Town of Surfside

RFQ 2022-05

Construction of Town of Surfside 96th Street Park

Addendum No. 4

SHEET A-3.1

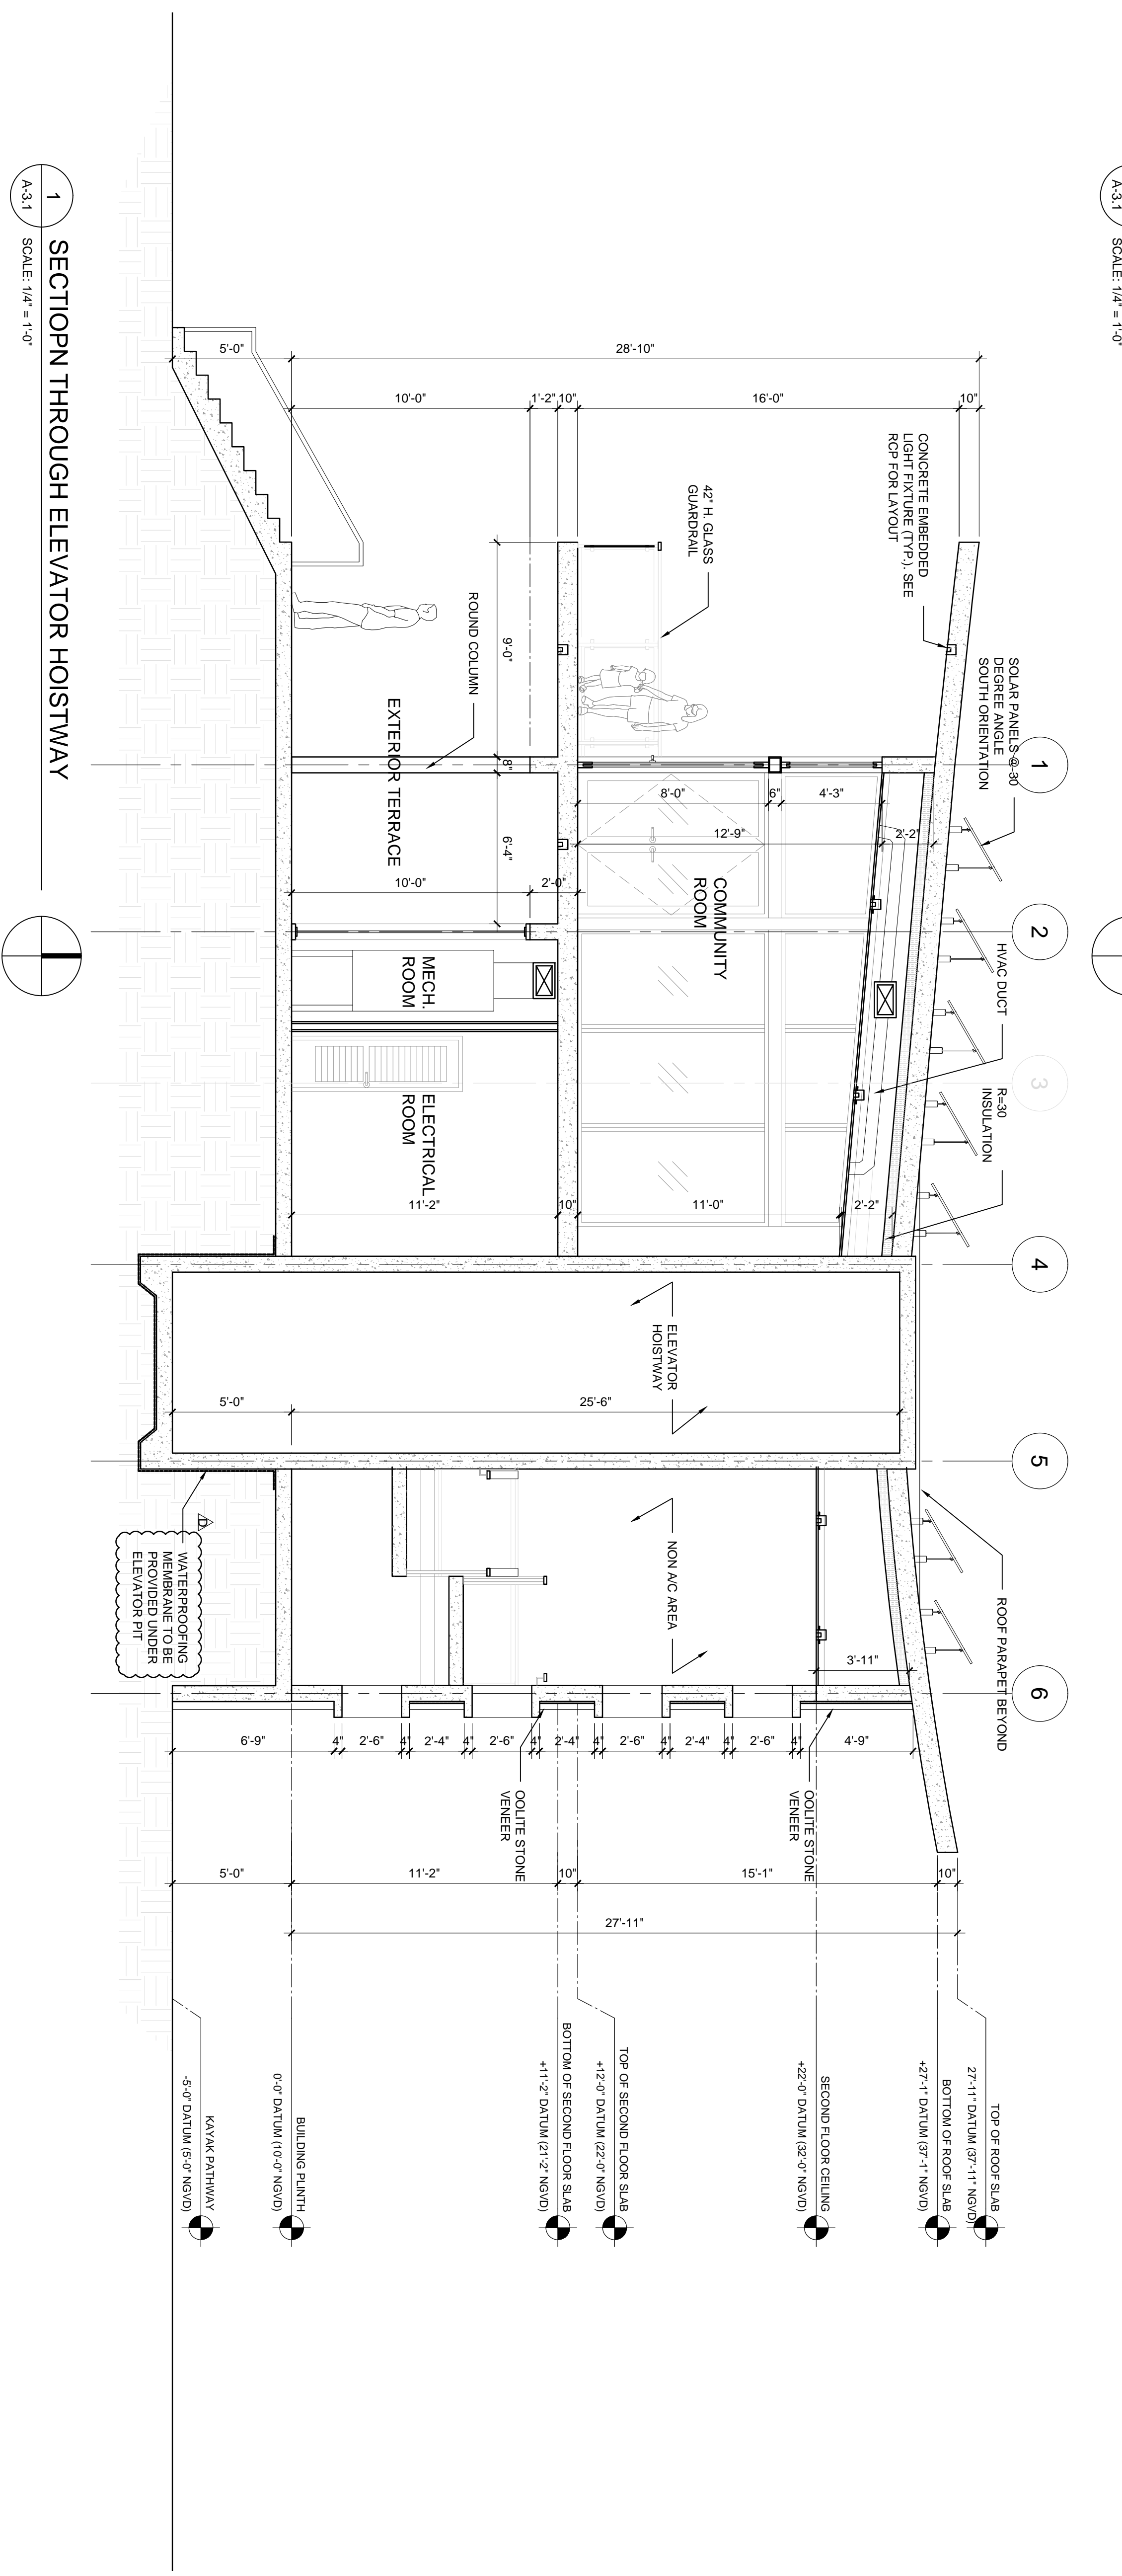
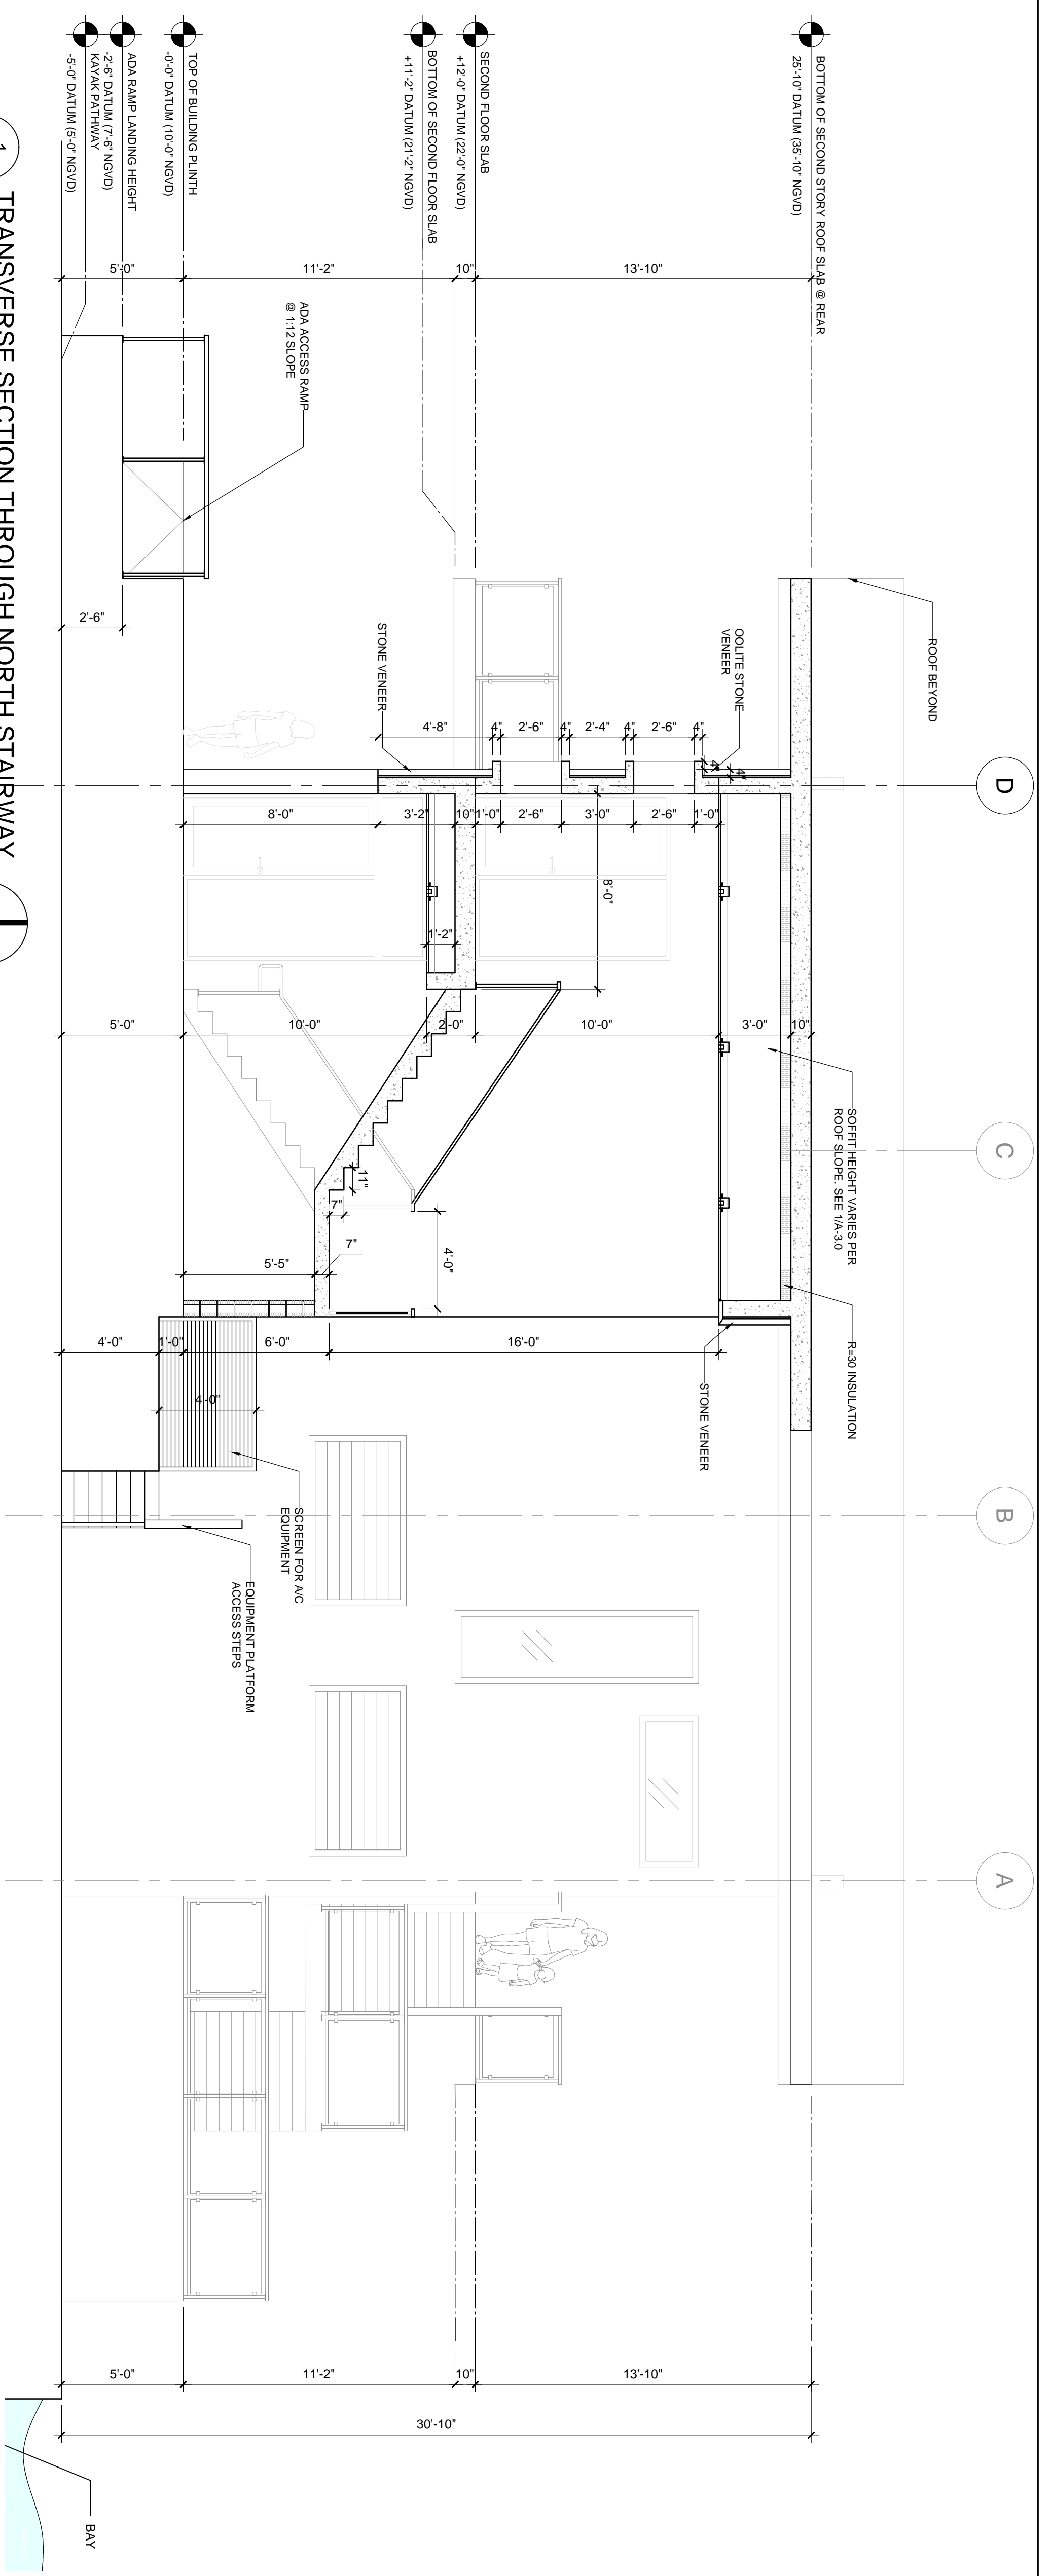
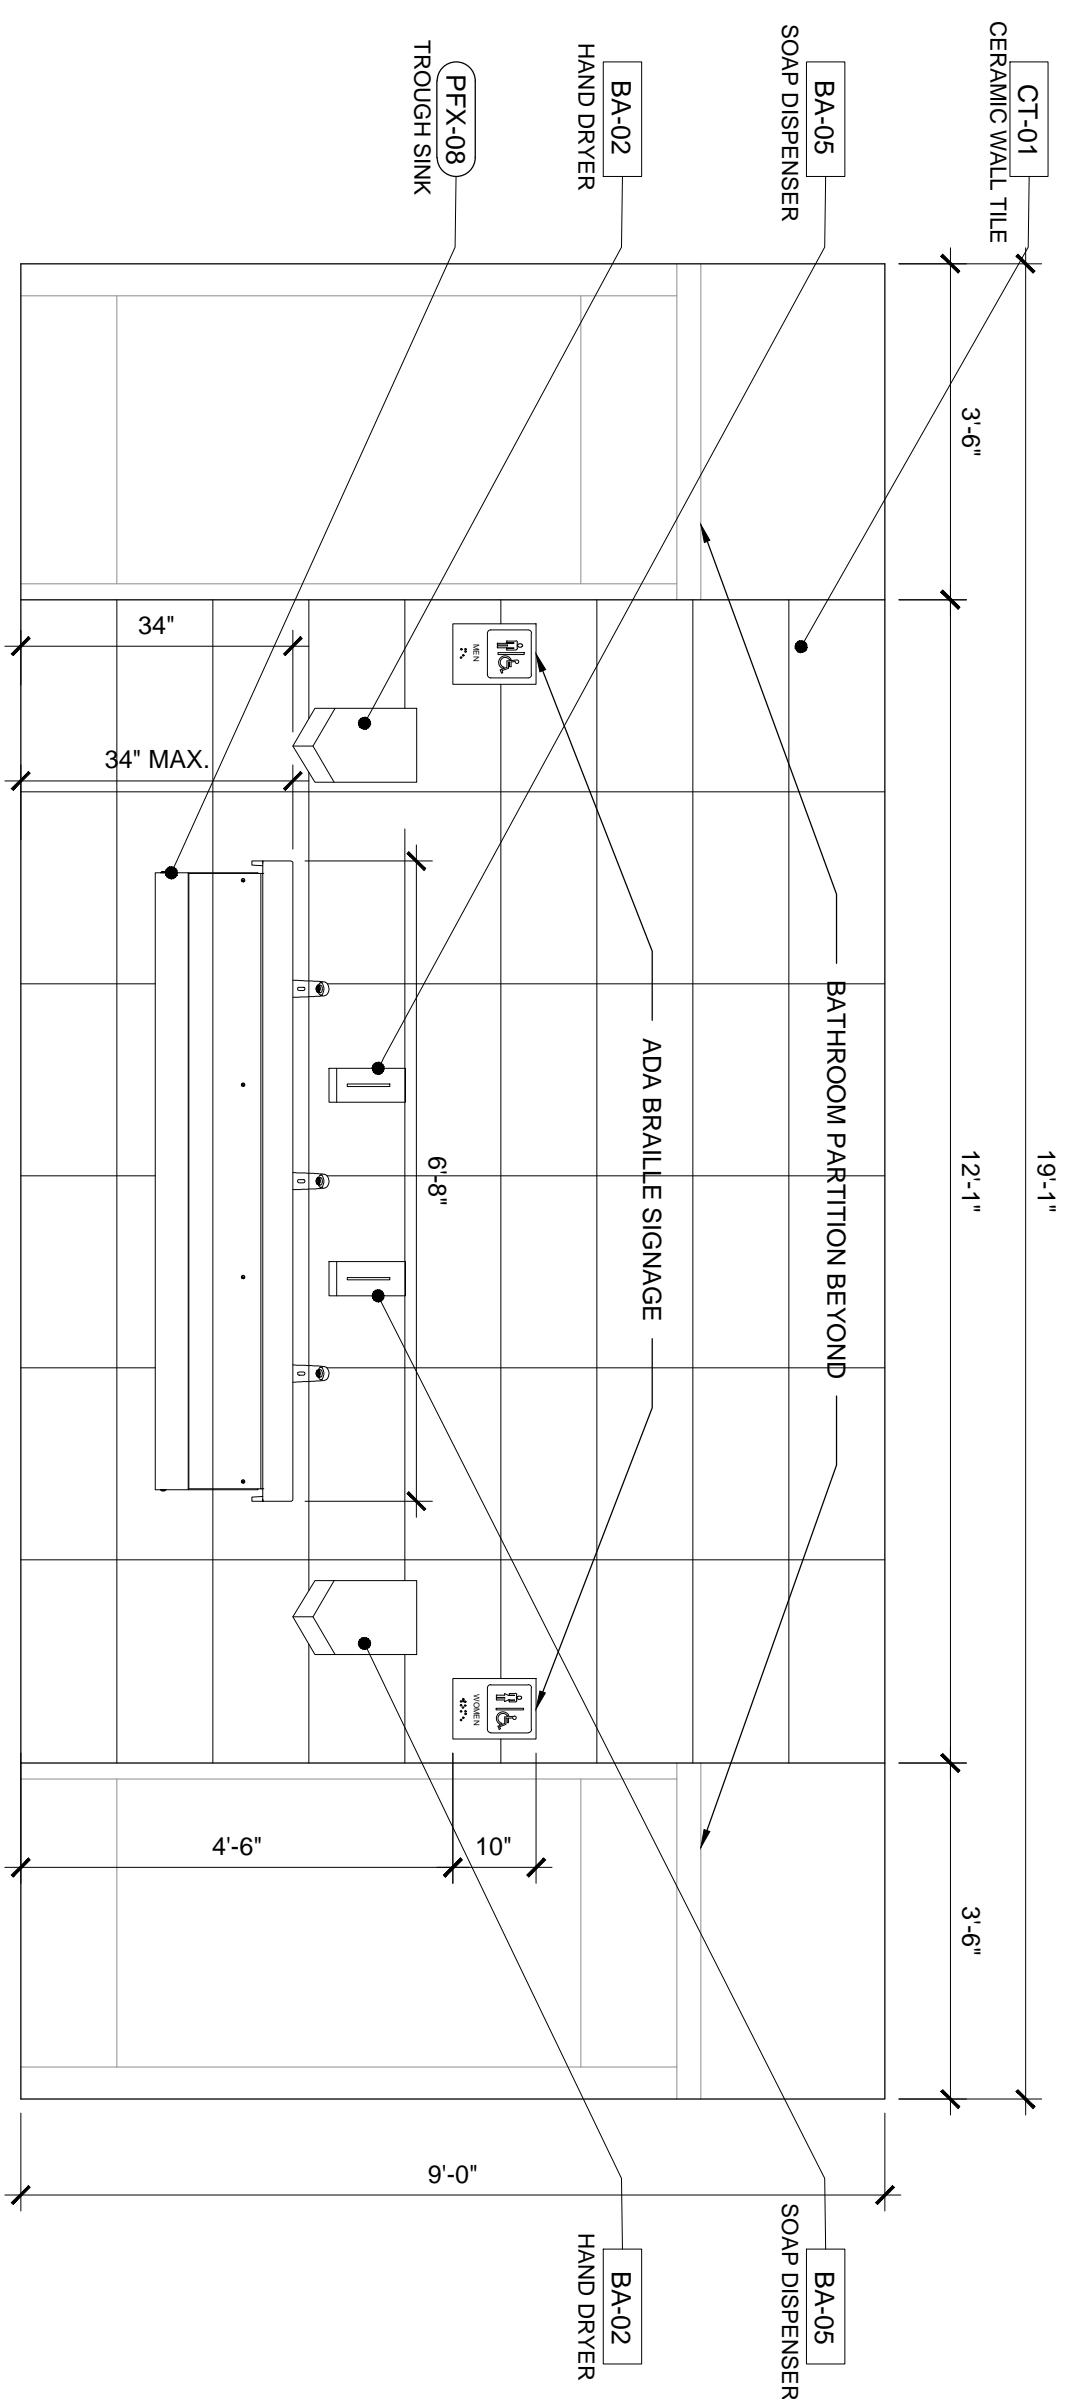
55. Plans do not specify any waterproofing membrane under the ground floor slab or elevator pit. Please confirm that no waterproofing will be needed in these areas.

Updated sheets A-3.0 & A-3.1 to indicate waterproofing membrane to be provided under elevator pit.
